### Staff Report: Z-45-22-8

July 1, 2022

<u>Laveen Village Planning Committee</u> Meeting Date	July 11, 2022
Planning Commission Hearing Date	August 4, 2022
Request From:	<u>S-1</u> (Approved <u>C-2 HGT/WVR PCD</u> ) (Ranch or Farm Residence District, Approved Intermediate Commercial, Height Waiver, Planned Community District) (41.60 acres)
Request To:	<u>C-2</u> <u>HGT/WVR DNS/WVR</u> (Intermediate Commercial, Height Waiver, Density Waiver) (41.60 acres)
Proposed Use	Mixed-use development
Location	Southeast corner of 59th Avenue and Dobbins Road
Owner	Tyson Family, LTD, et al.
Applicant	Matrix at Dobbins
Representative	Jason Morris, Withey Morris, PLC
Staff Recommendation	Approval, subject to stipulations

Proposed Site Plan; Source: Rick Engineering Company, Burton Landscape Architecture Studio, SVA Architects

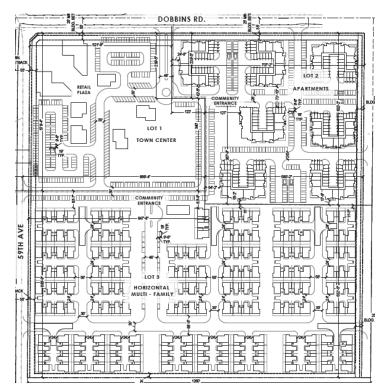
5. The conceptual site plan proposes both commercial and residential uses. Staff is recommending general conformance to the site plan, per Stipulation No. 1, to ensure the site is developed as depicted on the site plan.

> The site will have ingress and egress to both 59th and 57th Avenues, and Dobbins Road. Per Stipulation No. 2, primary entryway to Dobbins Road will have enhanced landscaping.

- 1. The development shall be in general conformance with the site plan date stamped June 30, 2022 and elevations date stamped May 27, 2022, as modified by the following stipulations and approved by the Planning and Development Department.
